M E M O R A N D U M

SUBJECT: **SP24-012: Parker Central Area F5 L2 B1 - McDonalds– Site Plan Amendment**
Review Comments 03

SITE DEVELOPMENT PLAN
MCDONALDS REMODEL AT PARKER CENTRAL AREA
FILING NO. 5, BLOCK 1, LOT 2

SHEET NO:
LI1.0

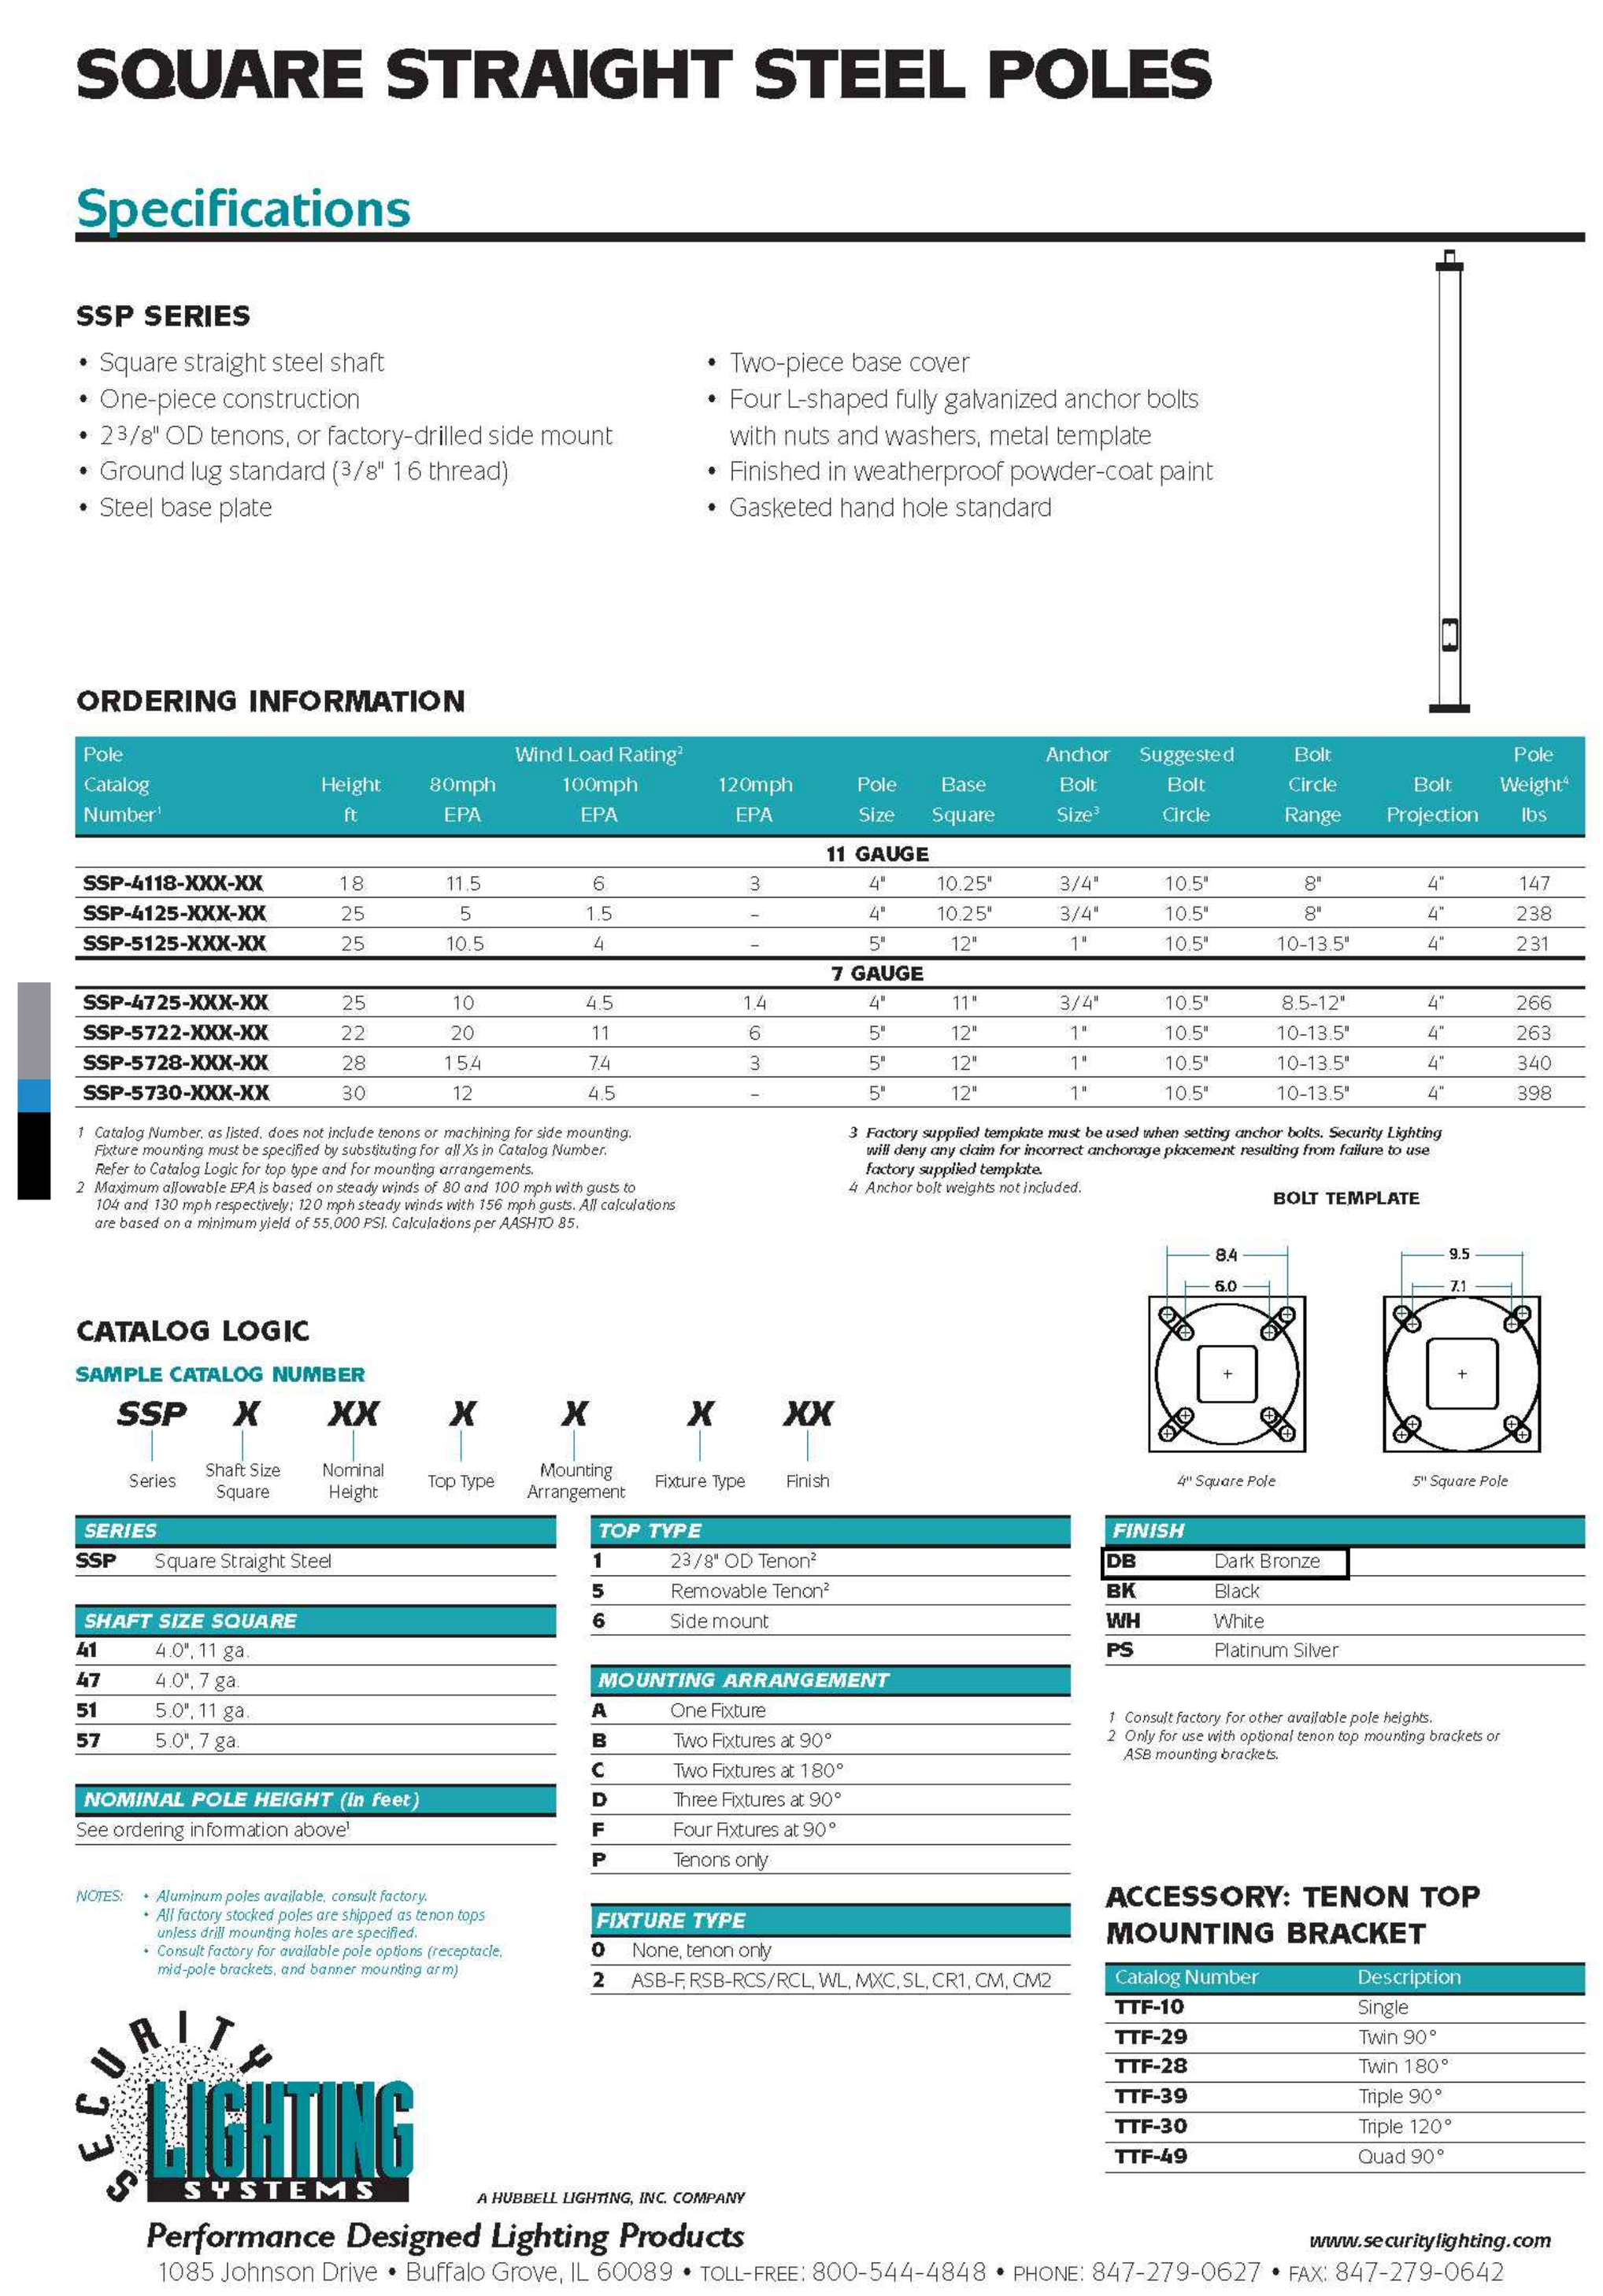
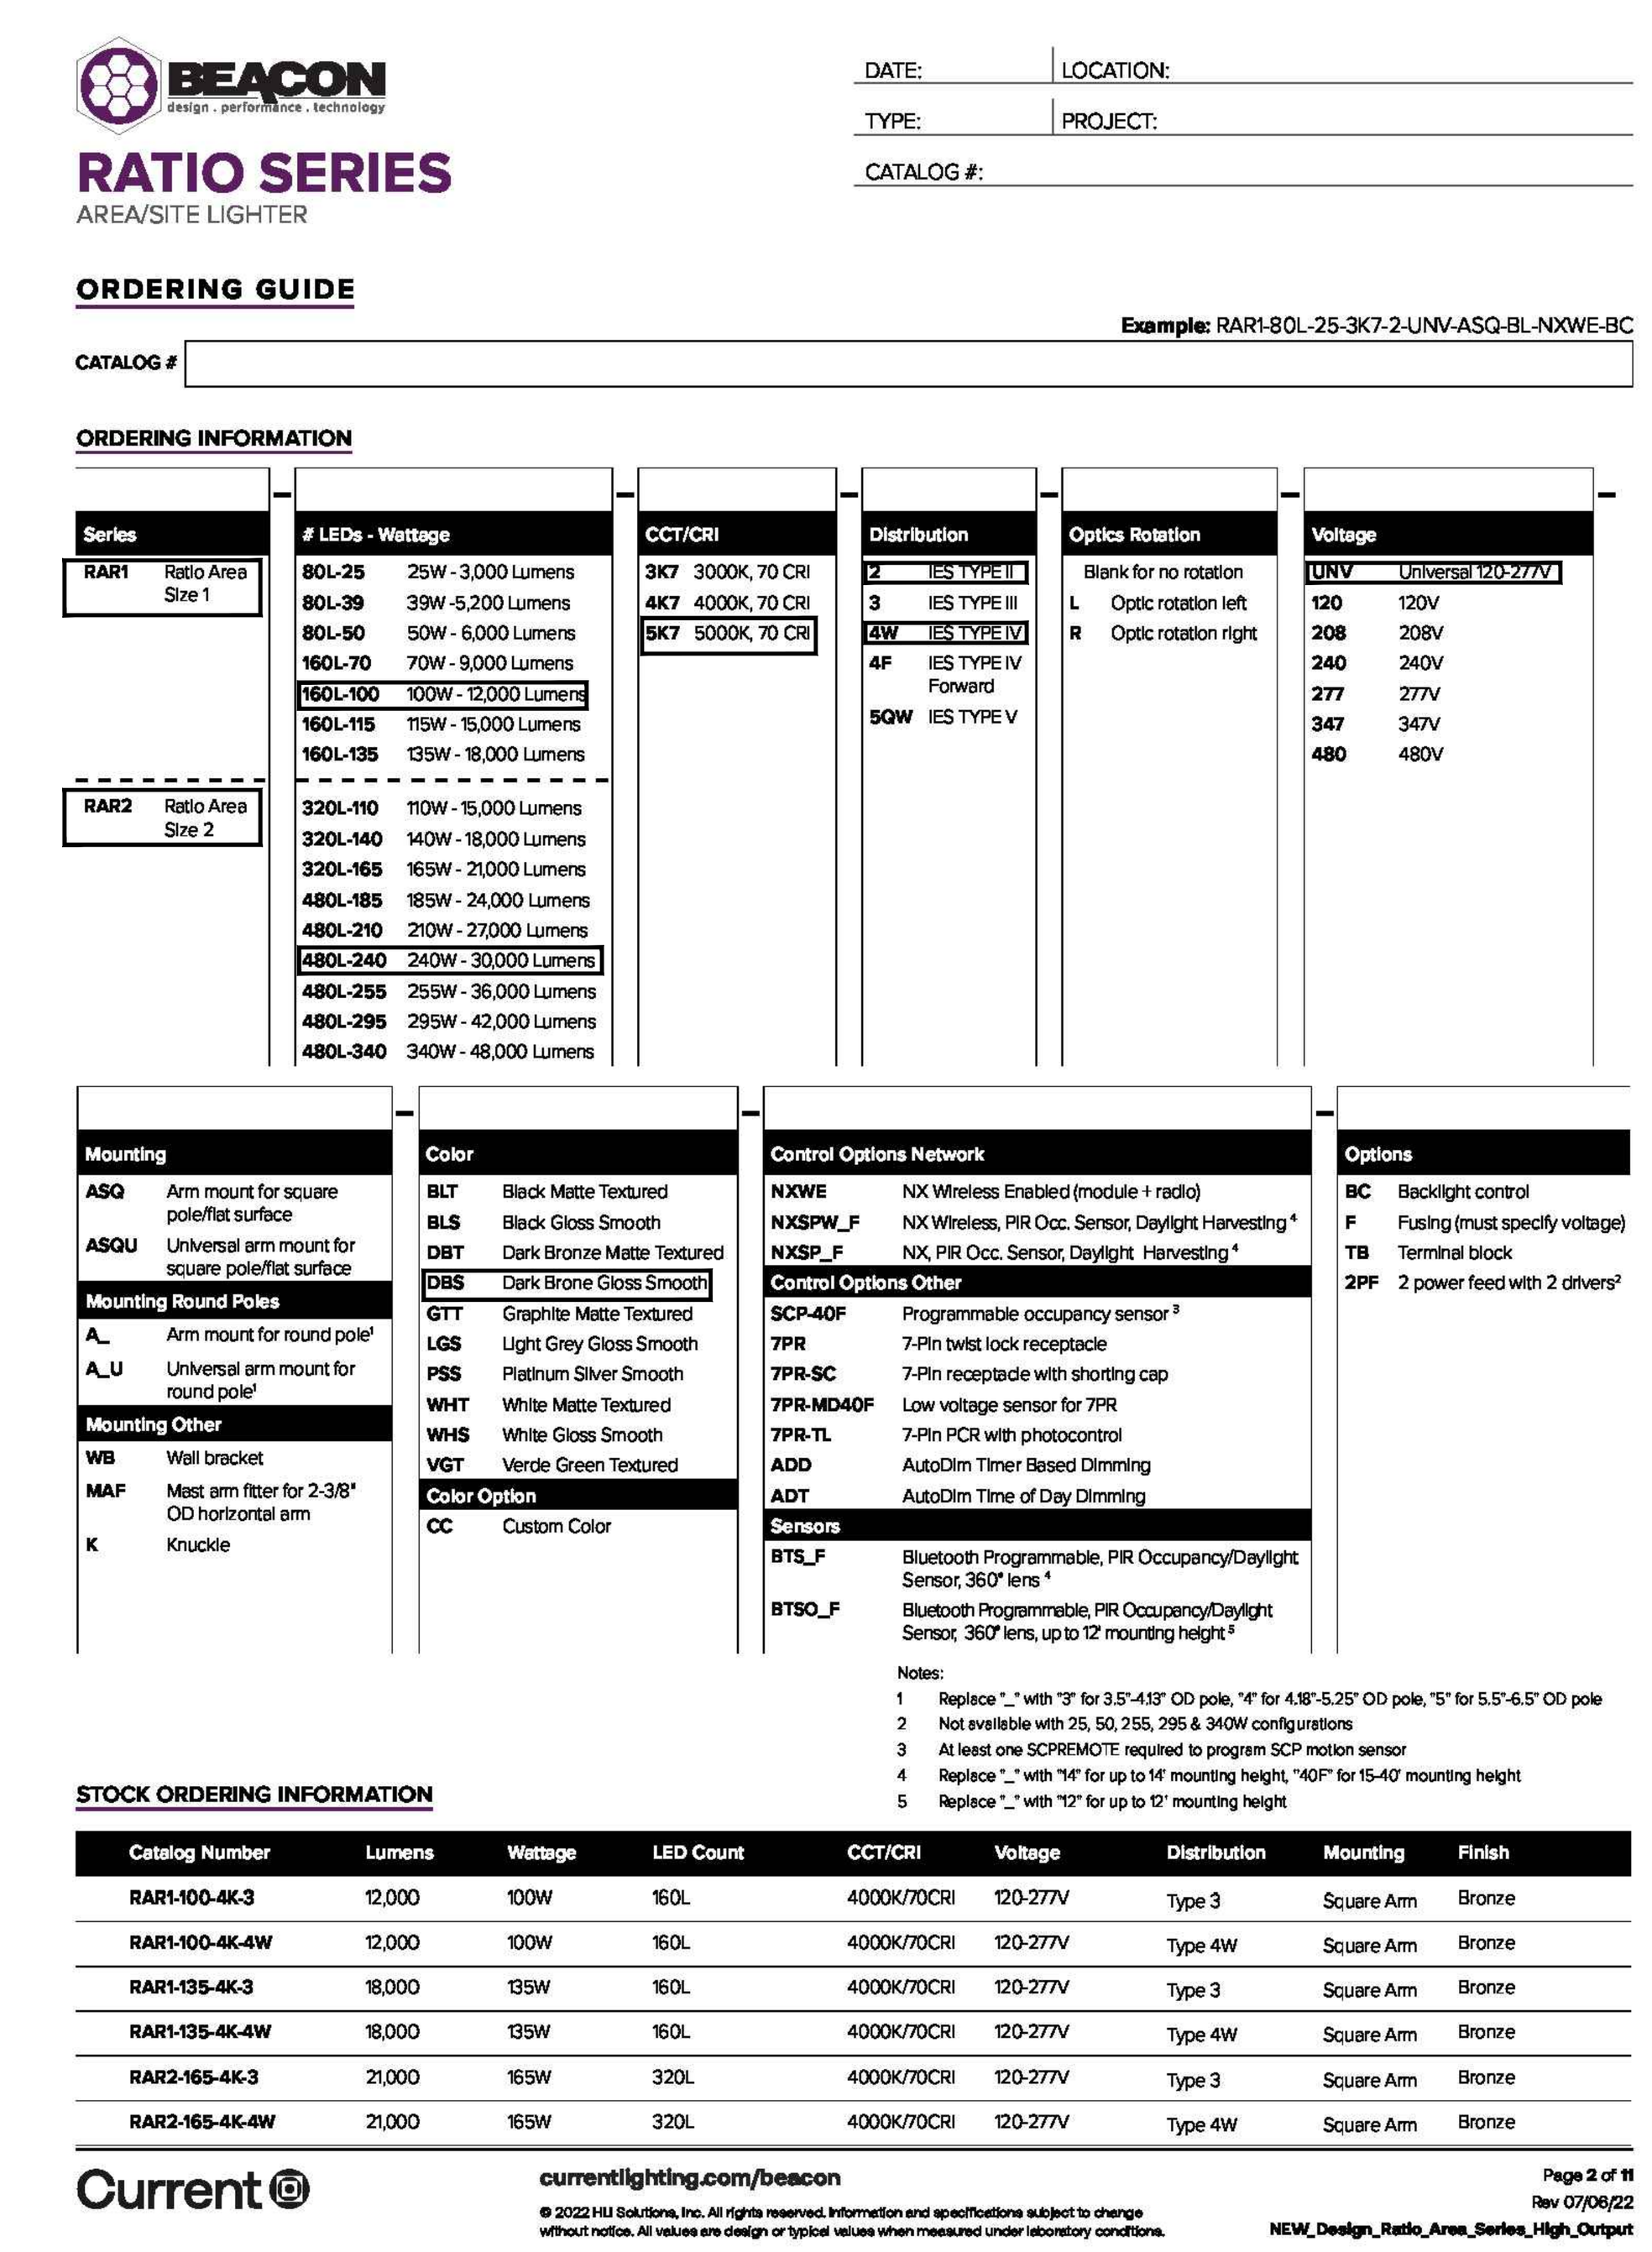
Update table. Per LDO Administrative Manual Section B.2.(f). Photometric Plan needs to include a table with the following information: light fixture,name, label, height, fixture color, total lumens, lighting type - CCT. CCT shall be below 5001 Kelvin.
